26 April 2022

Michael Cassel
Secretary
Department of Planning, Industry and Environment
12 Darcy Street,
Parramatta NSW 2150

SECTION 4.55(1A) MODIFICATION APPLICATION Sydney Metro Martin Place Station Precinct – North Site (SSDA 9270) MOD 6

Figure 2 Proposed reconfiguration of lobby and location of glass wall

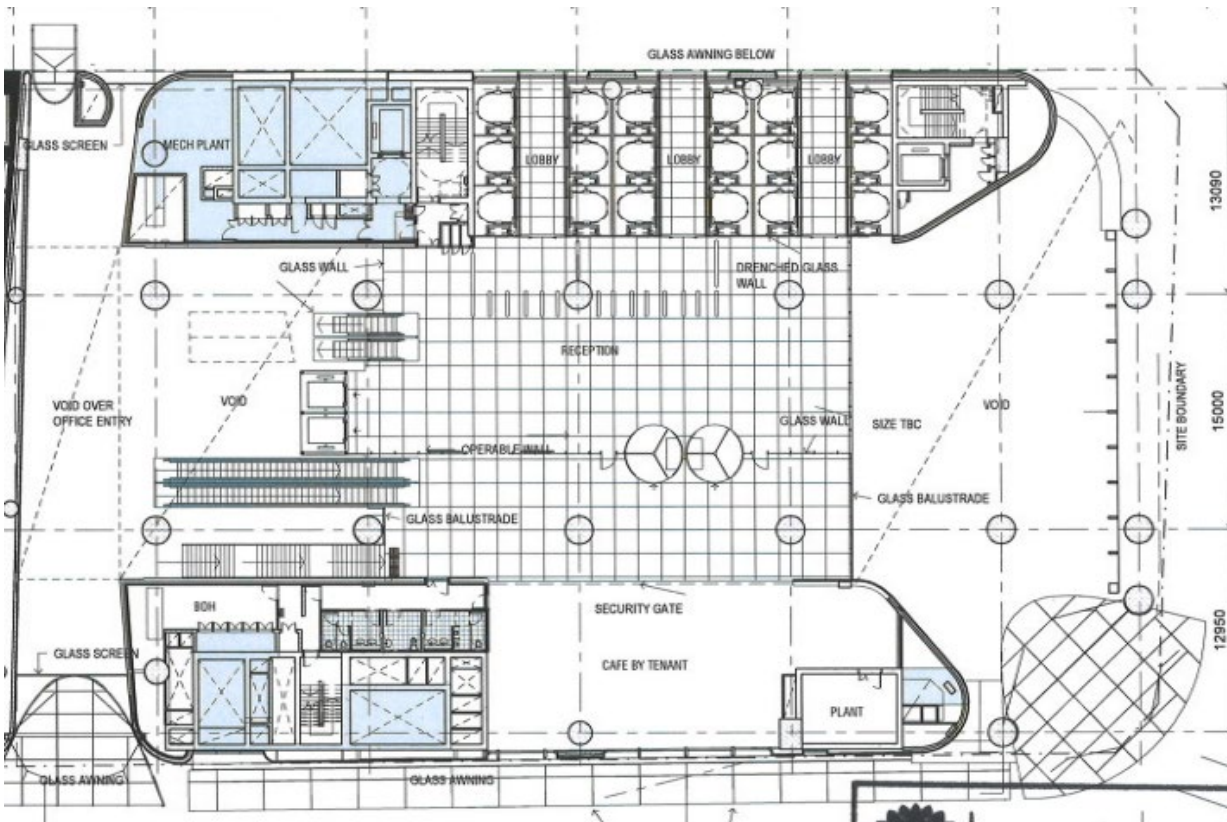
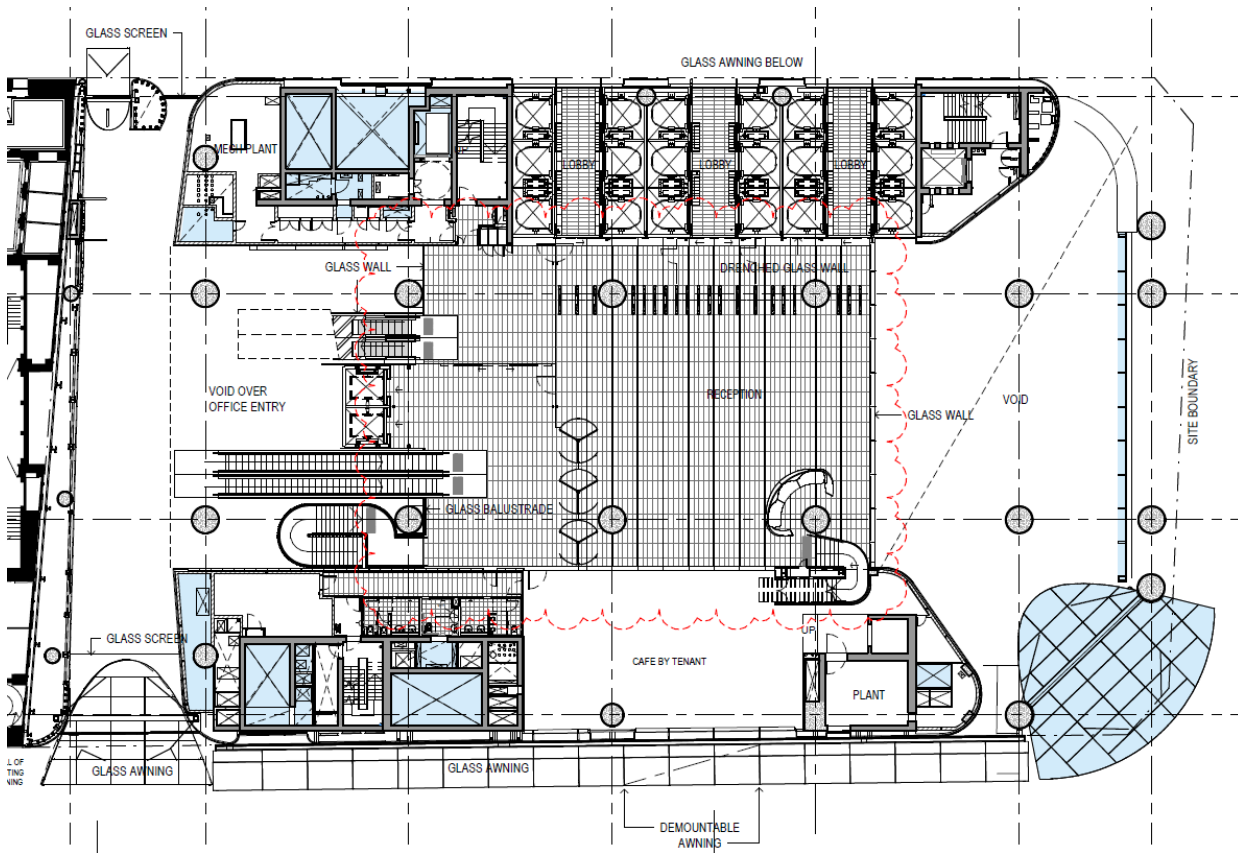
The application seeks minor variations to the approved configuration of the office lobby space on Level 1. The changes predominately comprise the reorientation of the revolving doors to an east-west orientation (previously approved in a north-south orientation), to accommodate revised movement and flow of users within the space. An additional revolving door has also been included to maximise access into the reception area. Security gates to access the building have been shifted further north to allow for direct access into all lobbies from the reception area. Additional gates have also been included to enhance pedestrian flow.

Additionally, the application seeks to amend the eastern portion of the previously approved glass balustrade to the north of Level 1 (overlooking the northern void space) to comprise full height glazing across Levels 1 and 2. **Figures 1 and 2** below show a comparison of the approved and proposed Level 1 floor plan respectively.

Figure 4 Proposed Level 20 plan showing relocation of inter-tenancy stairs and minor adjustment of atrium

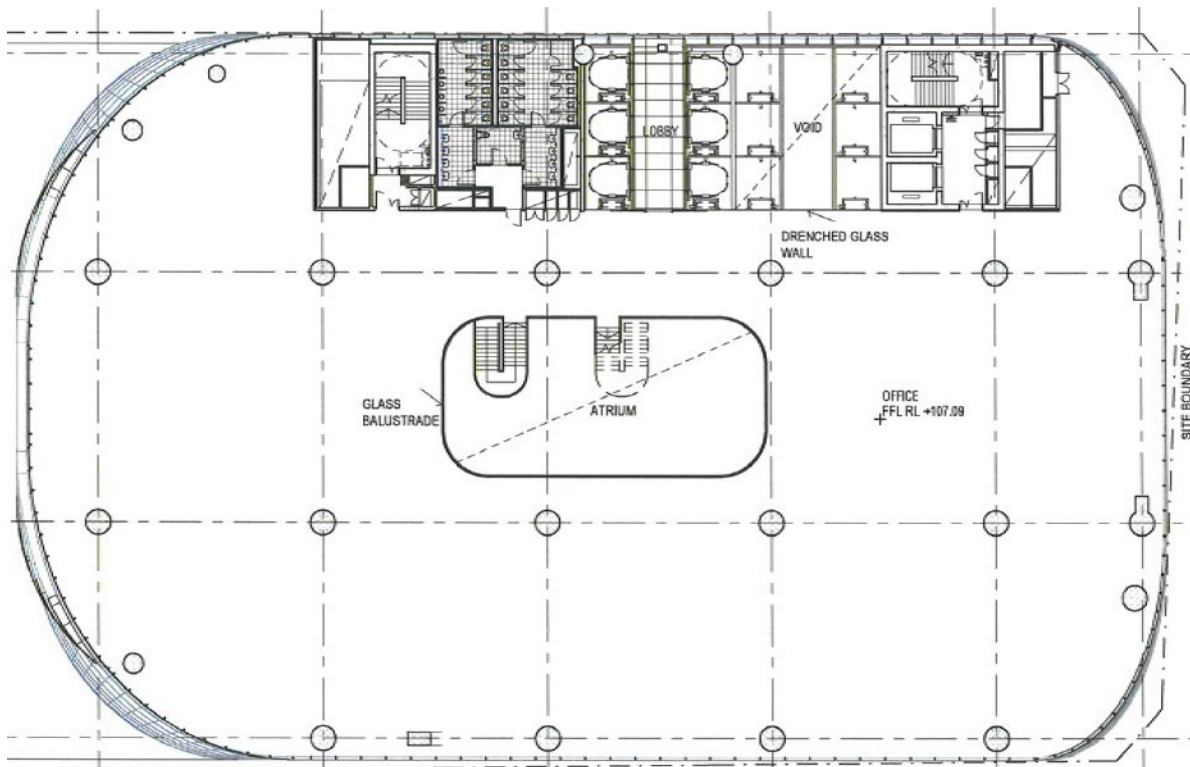
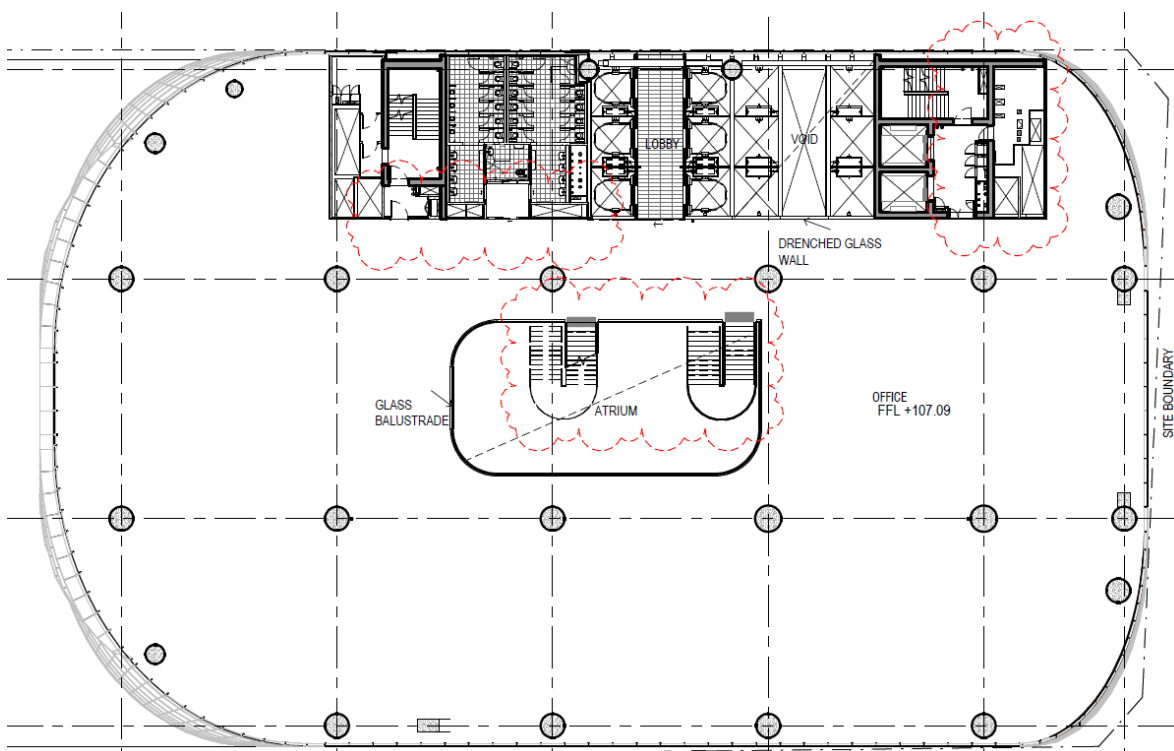
This application also proposes minor readjustments to the size and location of the inter-tenancy stairs on levels 19 to 27 and minor readjustments to the atrium size and shape on Levels 17, 18, 20, 21, 23, 26 and 27. A typical example of the changes, taken from the approved and proposed Level 20 plan, is shown in **Figures 3 and 4** respectively which illustrate a slightly altered atrium shape and relocation/expansion of inter-tenancy stairs.

Figure 5 Approved stamped Level 16 plan showing inter-tenancy stair

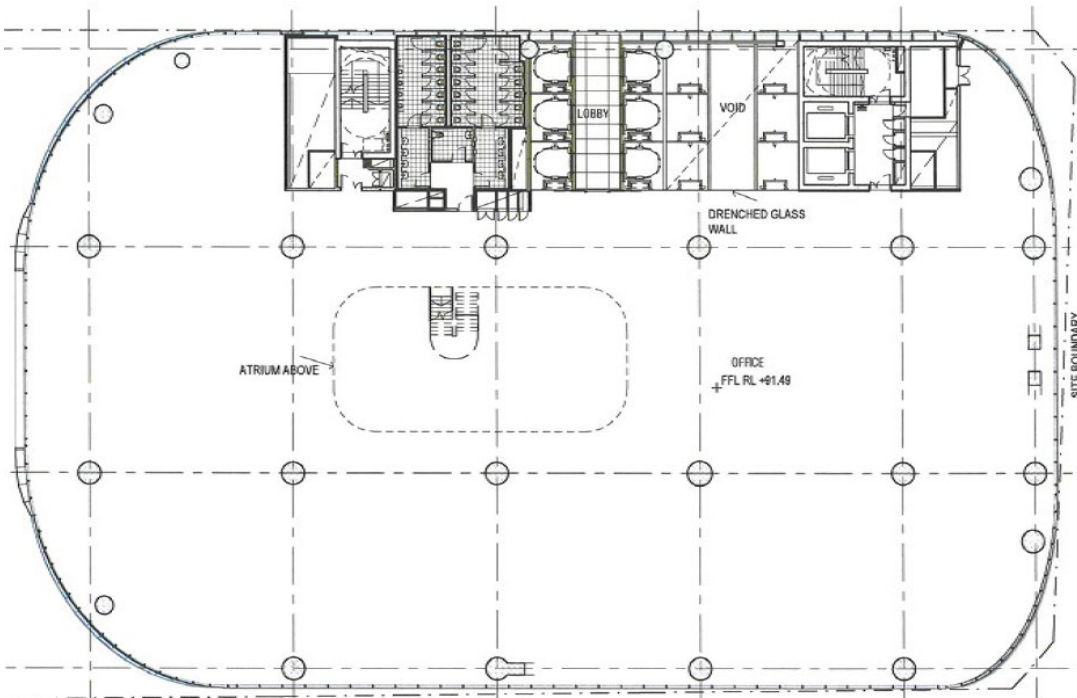
It is also proposed to remove the inter-tenancy stair on Level 16 to respond to workplace design requirements. A comparison of the approved Level 16 and proposed plan is provided in **Figures 5 and 6** respectively. The proposed changes are typical of the evolving design development process and are considered an improvement to the approved development from a functionality and useability perspective.

Figure 7 Approved section (left) and proposed section (right) showing fire separation slab extended

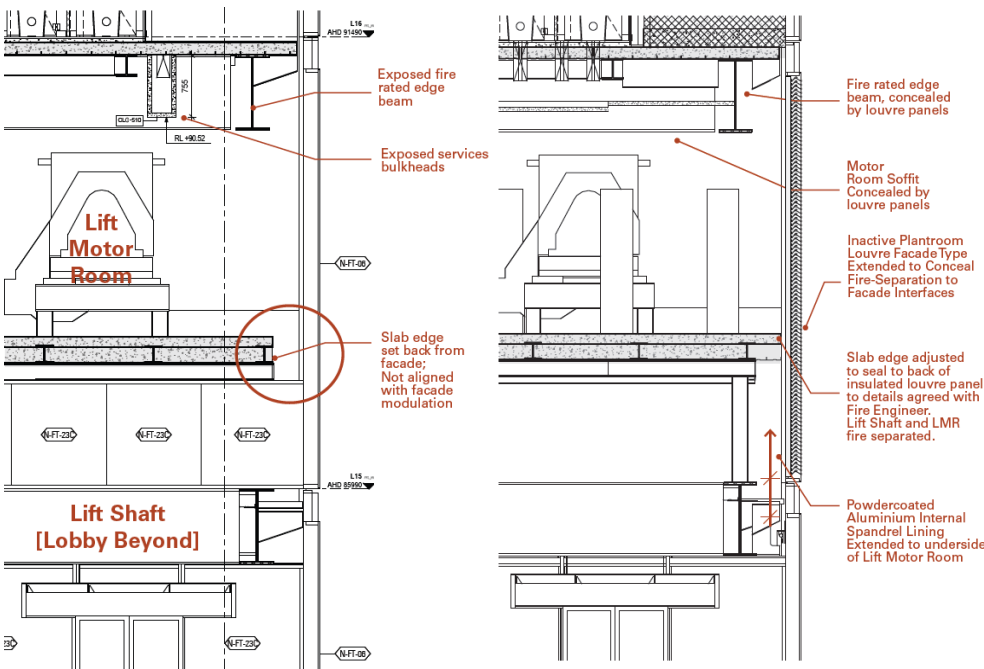
A minor change to the lift motor rooms on Levels 15 and 28 is proposed, being a minor extension of the floor slab to the inside edge of the façade transom. The slab extension is proposed to create fire separation to the lift shaft level below. Section drawings showing the approved and proposed arrangement are shown in **Figure 7**, and a view in plan is shown in **Figure 8**.

Figure 8 Level 15 Plan view extract showing lift motor room and fire separation slab extended (proposed)

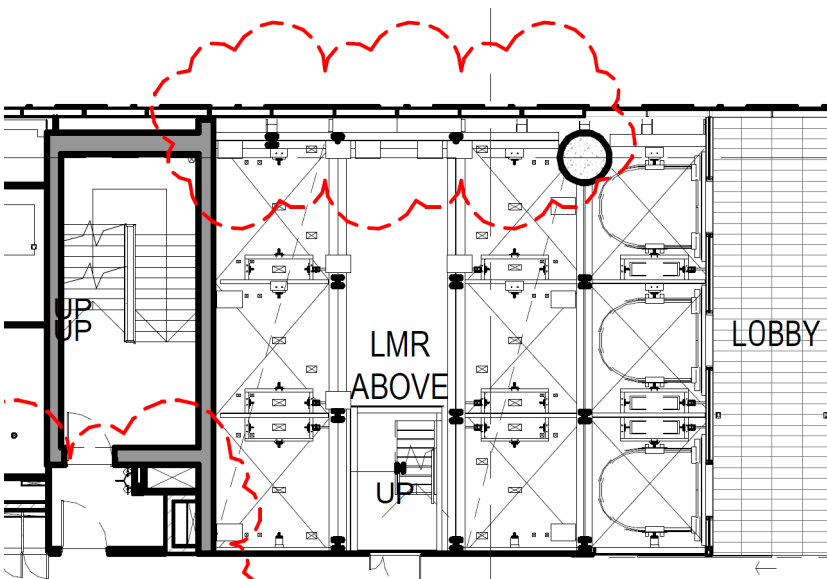
A continuation of the approved louvres on the western façade as recommended by the architects JPW is proposed on these two levels to conceal this change, as endorsed by DPE through the B5-B7 discharge request dated 25 March 2022, as discussed in **Section 2.6**.

Figure 10 Proposed balustrade height increase on eastern façade (replicated on north and west) and Level 11 exhaust discharge (right)

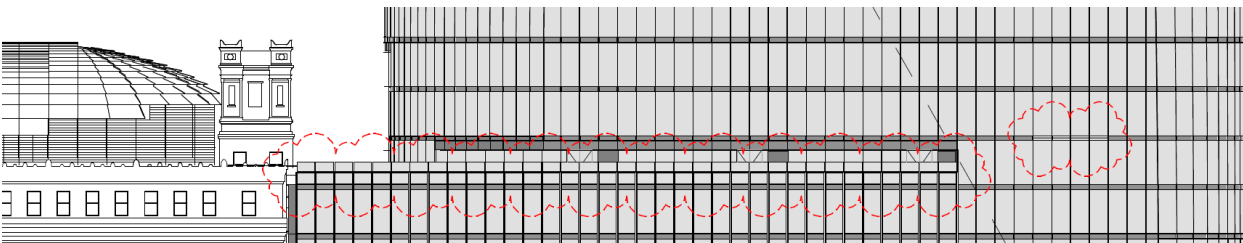
- Increase in height of Level 10 balustrade from 1,375mm to 1,800mm.
- Inclusion of exhaust on Level 11.
- Inclusion of hatch and generator flues on Level 28.

- An increase in balustrade height from 1375mm to 1800mm on level 10 on the northern, eastern and western elevations (approved and proposed elevations of the eastern façade showing the proposed change are shown in **Figure 9** and **Figure 10** respectively);
- A minor increase in louvres on Level 15 and Level 28 is proposed in lieu of glazing on the western façade to screen the visible lift motor room and maintain architectural integrity, as shown in **Figure 11**;
- Minor changes to eastern façade comprising:
 - Inclusion of exhaust on Level 11 (refer to **Figure 10**);
 - Inclusion of generator flues on Level 28 (refer to **Figure 12**).
- Removal of visible BMU door rails; and
- Reduction of BMU door extent on Level 28 and the Upper Roof Level, along the southern elevation (refer to **Figure 13**).

Figure 11 Western elevation showing increase in louvres on Levels 15 and 28 (proposed)

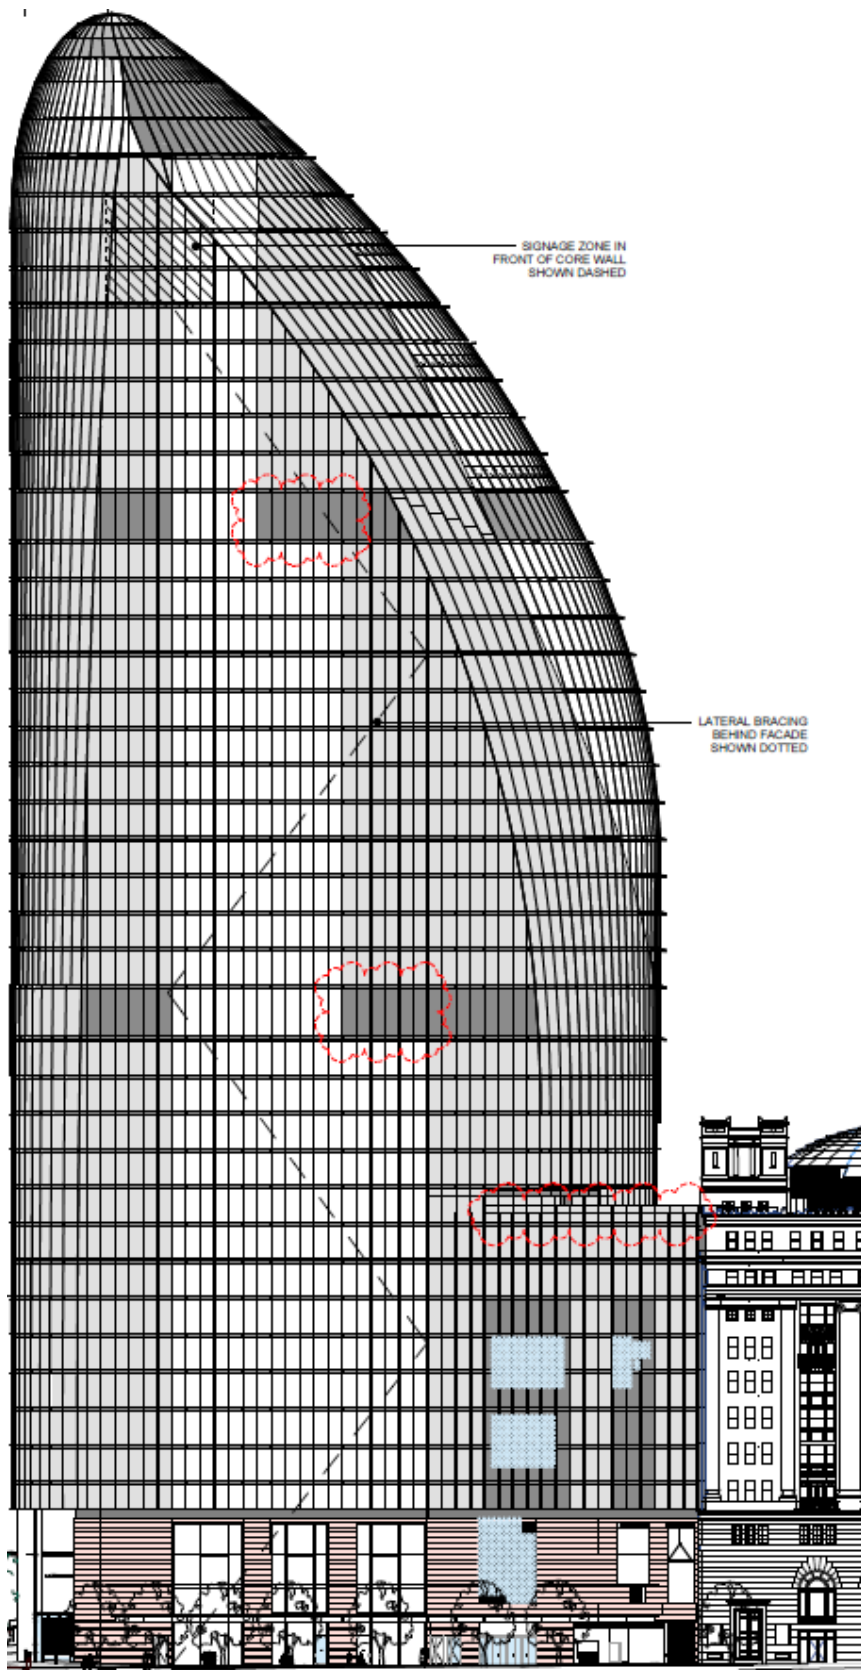
- Increase in louvres on Levels 15 and 28 in lieu of glazing on western façade.
- Increase in height of Level 10 balustrade from 1,375mm to 1,800mm.

Figure 13 Southern elevation showing reduction of BMU door extent on Level 28 and Upper Roof (proposed)

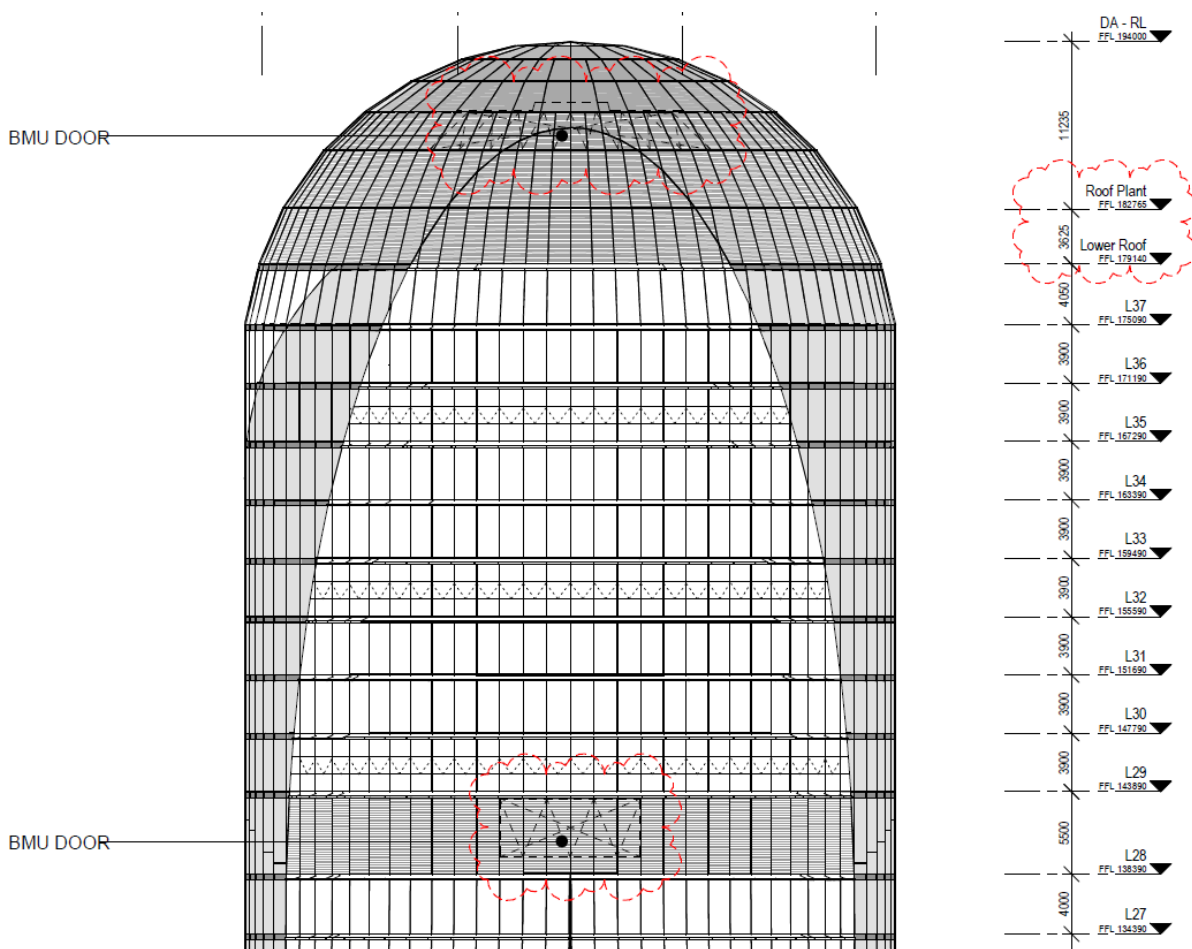
- Level 28 BMU door extent reduced.
